ITEM 11. DEVELOPMENT APPLICATION: 18 HUNTLEY STREET
ALEXANDRIA

FILE NO: D/2015/1718

SUMMARY

Figure 23: North-south section plan of Section B

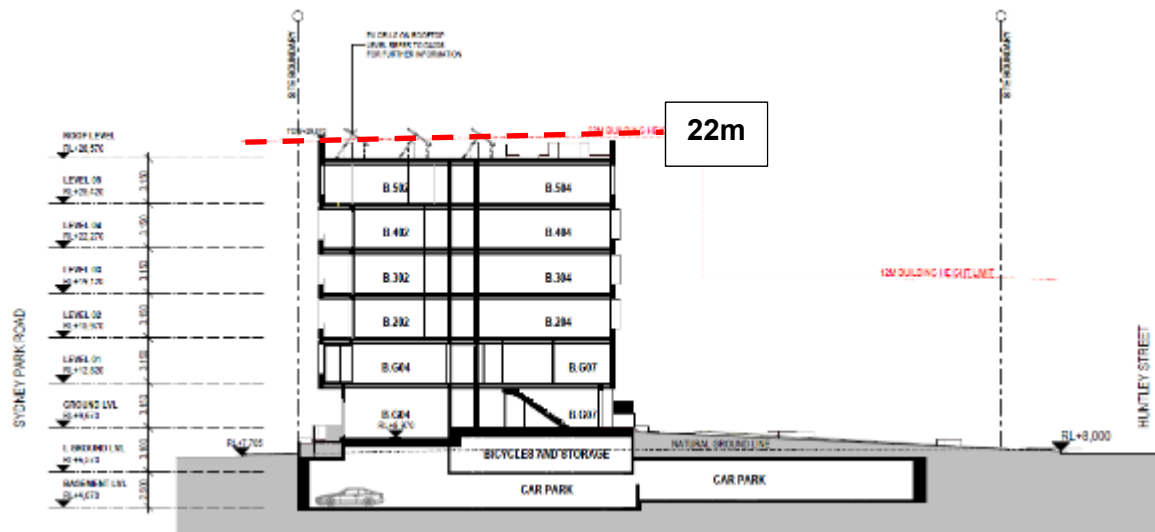
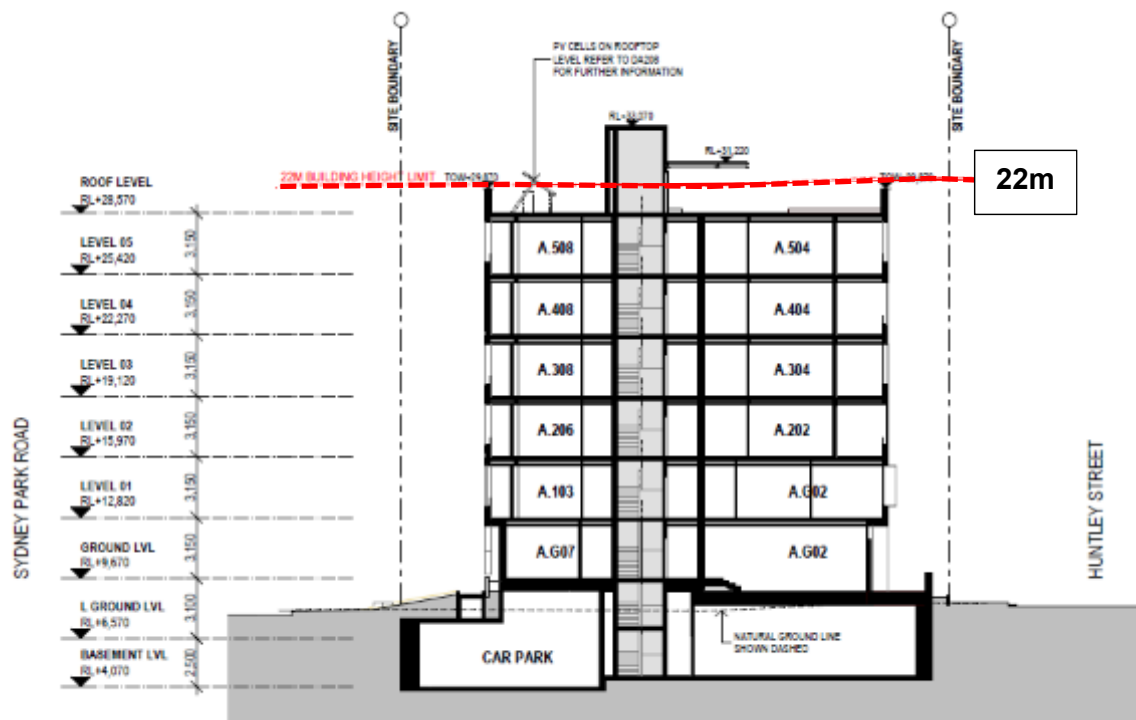
54. The proposal complies with the 12m height of buildings development standard along the Huntley Street frontage. With regards to the remainder of the site, a height of 25.06m is proposed. This represents a 3.06m or 13.9% exceedance of the height of buildings development standard.

Figure 27: Axonometric view of proposed development

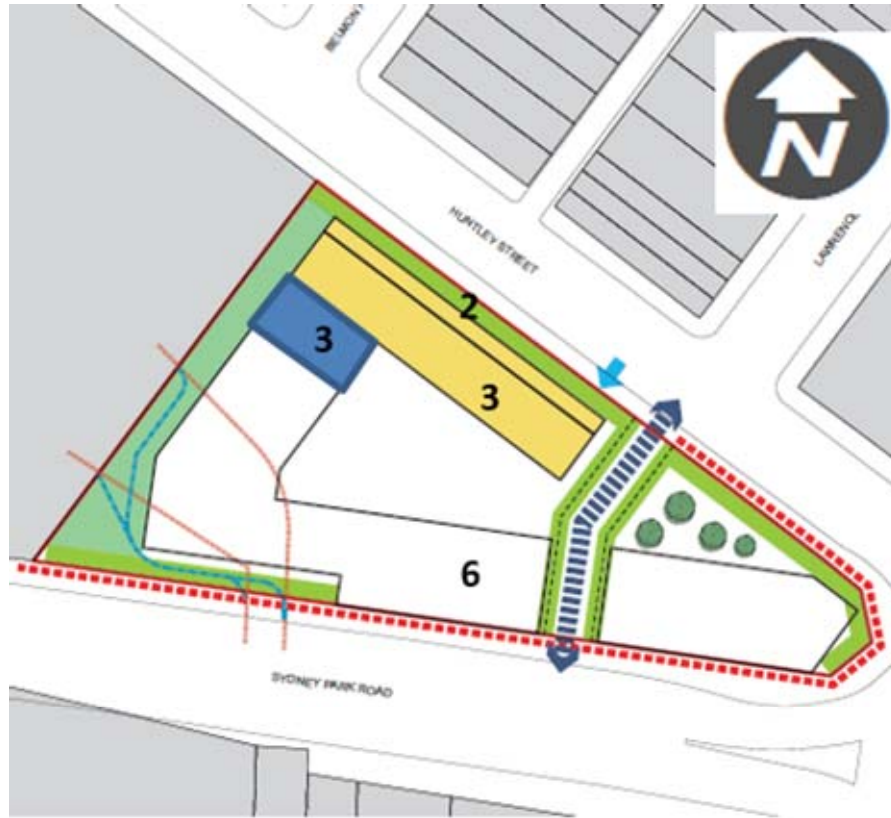
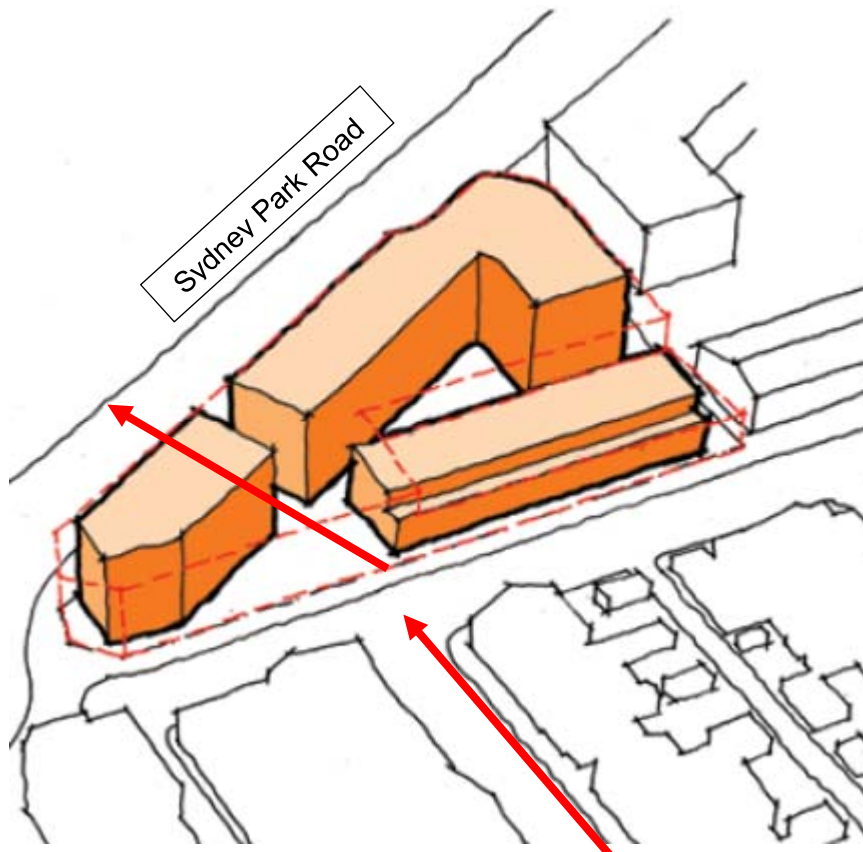
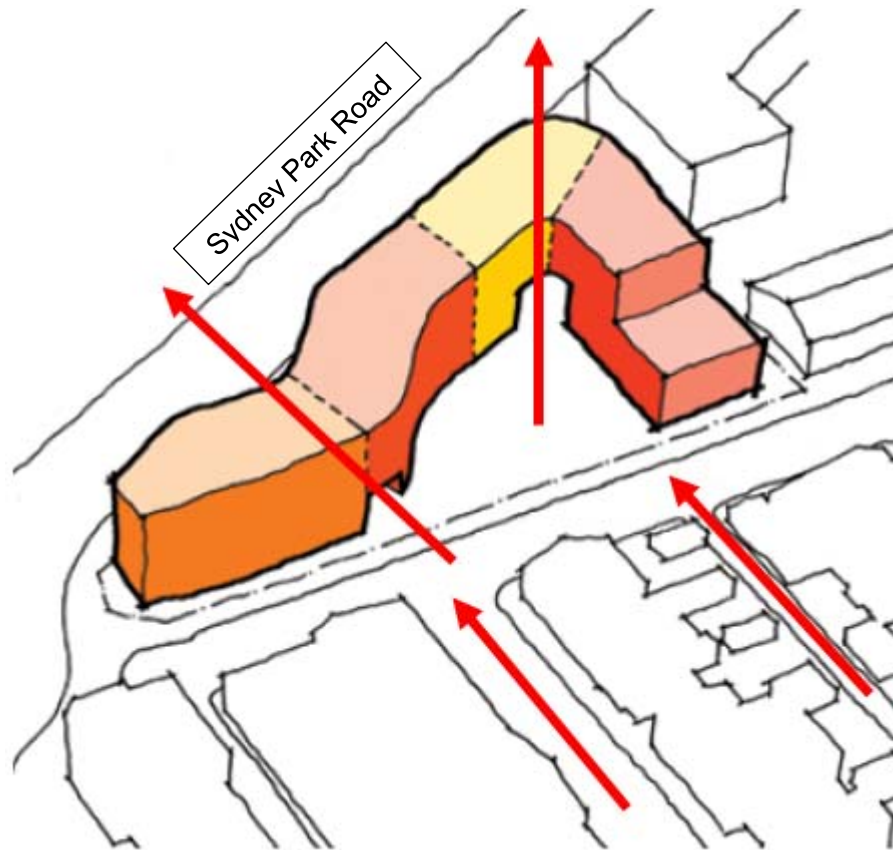
- (b) creation of a three storey (instead of a two storey with a third storey set back) building form along the western Huntley Street frontage;
 - (c) removal of the eastern section of the part two and part three storey building form facing Huntley Street to create a larger ground level open space, known in the application documents as 'Huntley Green';

- (d) building over in part the primary through-site link;
 - (e) creation of a second through-site link on the western side of the site; and
 - (f) moving of the vehicle access towards the western side boundary.

62. The variation in the site specific built form development controls and the proposed design is considered acceptable having considered the following:

Figure 30: Potential blast zone of a substation chamber located to the south of Lobby C

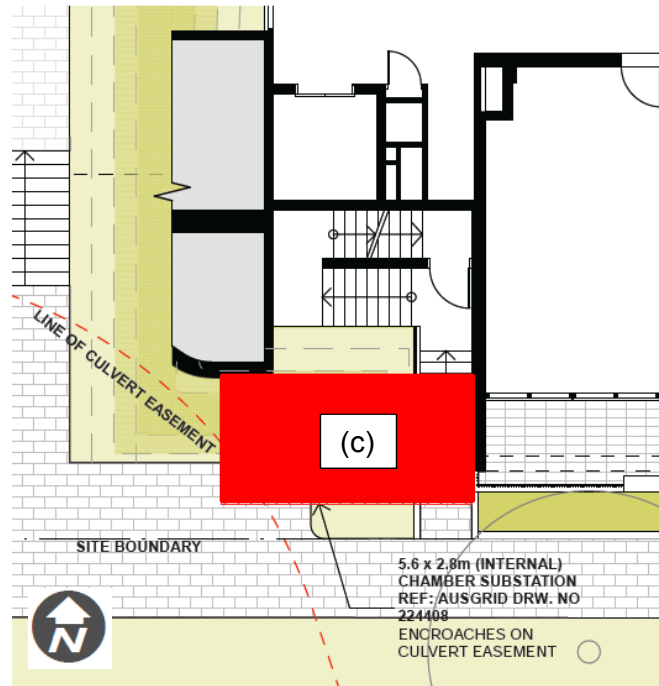
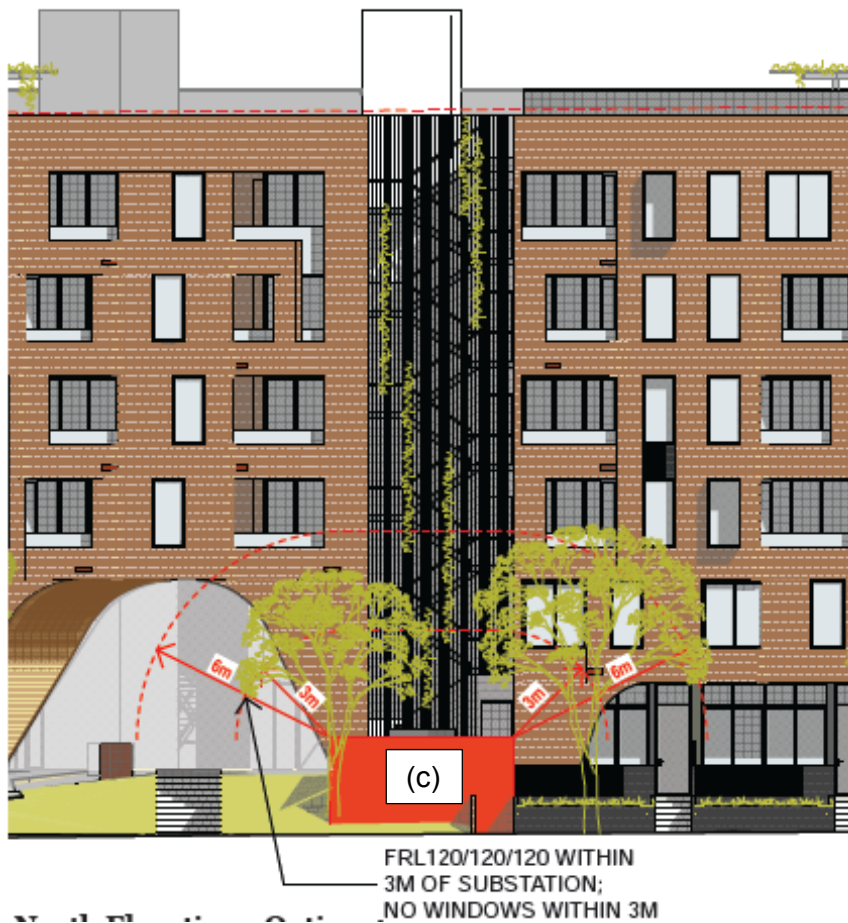
65. The above locations are not considered optimal locations as the potential blast zone of any substation in these locations would necessitate the creation of a large blank wall. Having a large blank wall located in a prominent location adjacent to a through-site link or the 'Huntley Green' open space would have a more detrimental visual impact than a standalone electricity substation located in the southwestern corner of the site. In addition, a substation located to the south of Lobby C would encroach on the Sydney Water easement (see figures below).

66. Accordingly, it is considered that the standalone electricity substation located in the southwestern corner of the site is acceptable in the circumstances. However, a condition is recommended requiring the design of the structure enclosing this substation be submitted to and approved by Council's Area Planning Manager prior to a construction certificate being issued.

Figure 31: Building separation between Sections C and D on Level 2

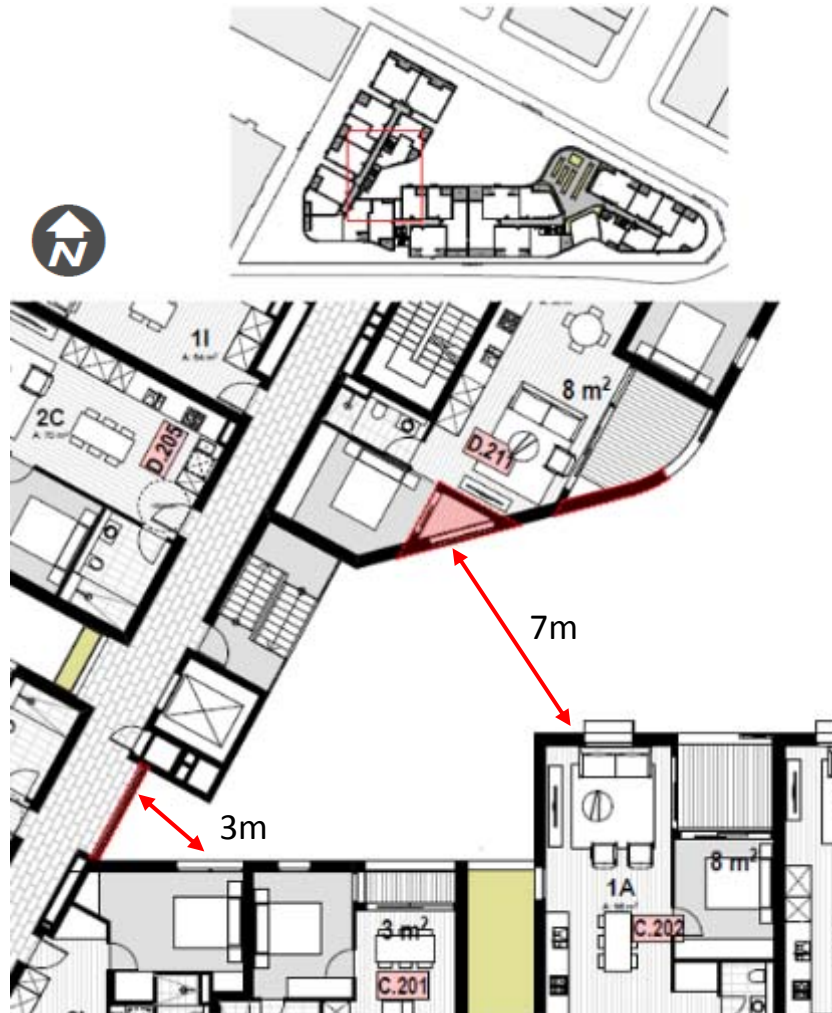
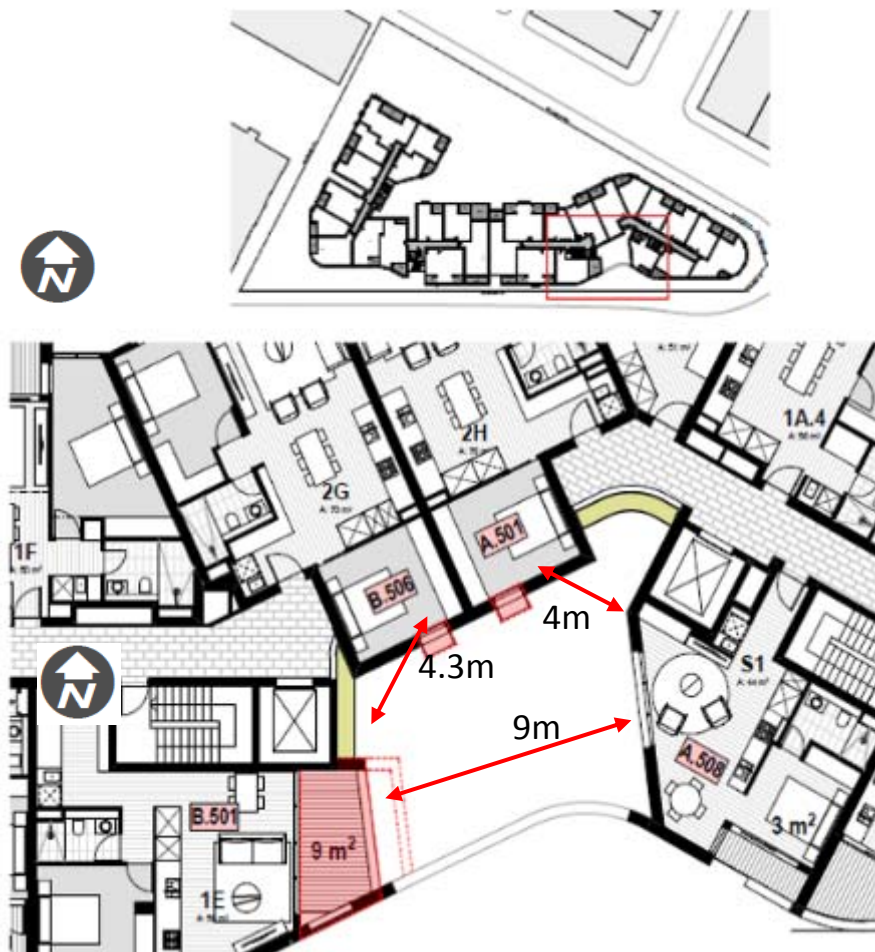
67. Infringements to the building separation control set out in the ADG occur in the 'elbow' locations separating Sections C and D and separating Sections A and B of the proposed development at their narrowest points as indicated in the below figures.

68. Considering the sole outlook of the primary living spaces of Units 206, A.308, A.408 and A.508 is to the west towards Units B.201, B.301, B.401, B.501 and the separation distance between these residential apartments on Levels 2 to 5 is only 9m, a design modification condition is recommended requiring the external window openings and internal layout of Units A.206, A.308, A.408 and A.508 be redesigned and reconfigured to ensure that the outlook of the primary living areas of these residential apartments is to Sydney Park to the south.

Figure 33: Proposed new location of food and drink premises

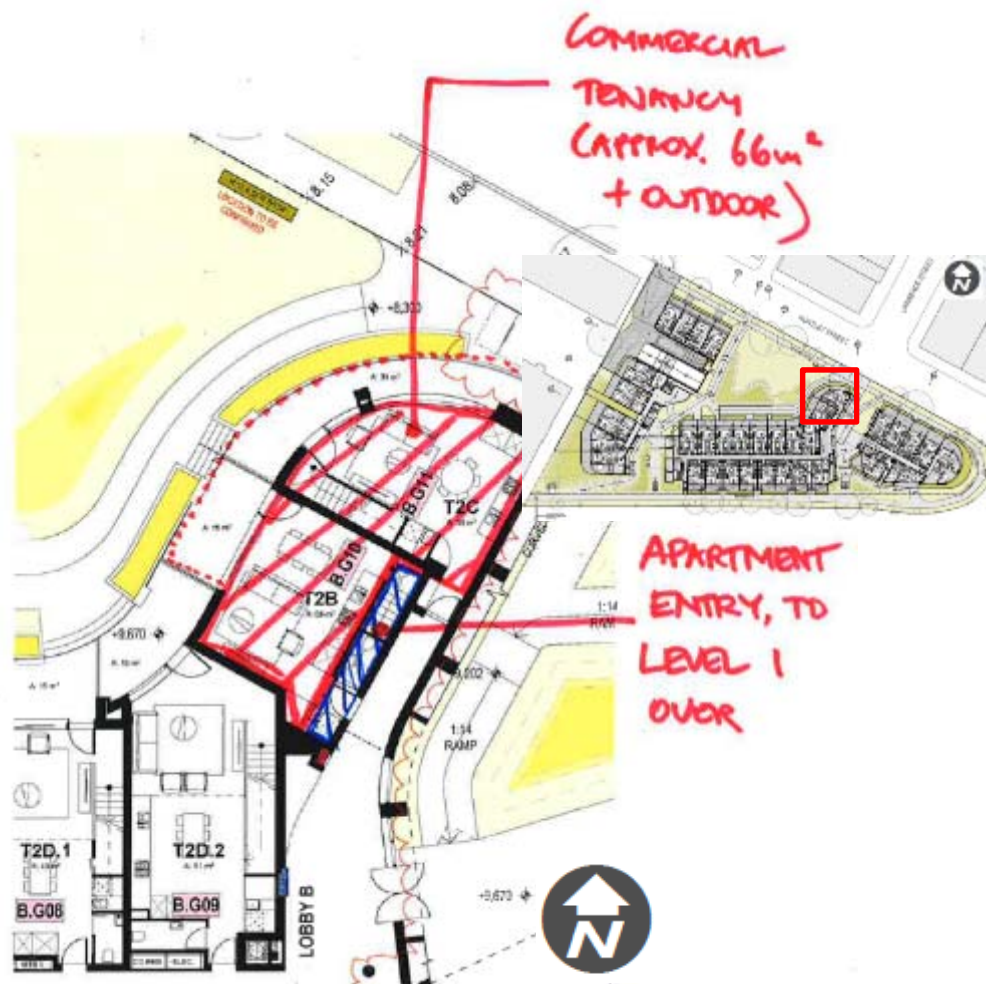
70. The applicant has explored the implementation of non-residential uses on the ground level in the proposed development. The application currently includes a food and drink premises on the ground level in Block D adjacent to the western through-site link. This proposed food and drink premises is poorly located and is not of sufficient size to significantly assist with the activation of the proposed 'Huntley Green'.

71. A design modification condition is recommended requiring the insertion of a more appropriately located and sized commercial tenancy next to the eastern through-site (see figure below). This commercial tenancy shall be approximately 66sqm with outdoor area in size. The space currently occupied by the proposed food and drink premises located adjacent to the western through-site link can be used as a goods and waste storage space for the new larger tenancy. Approval for this premises is only indicative – approval under a further development application or under complying development certificate shall be required prior to the fit out and use of this tenancy.
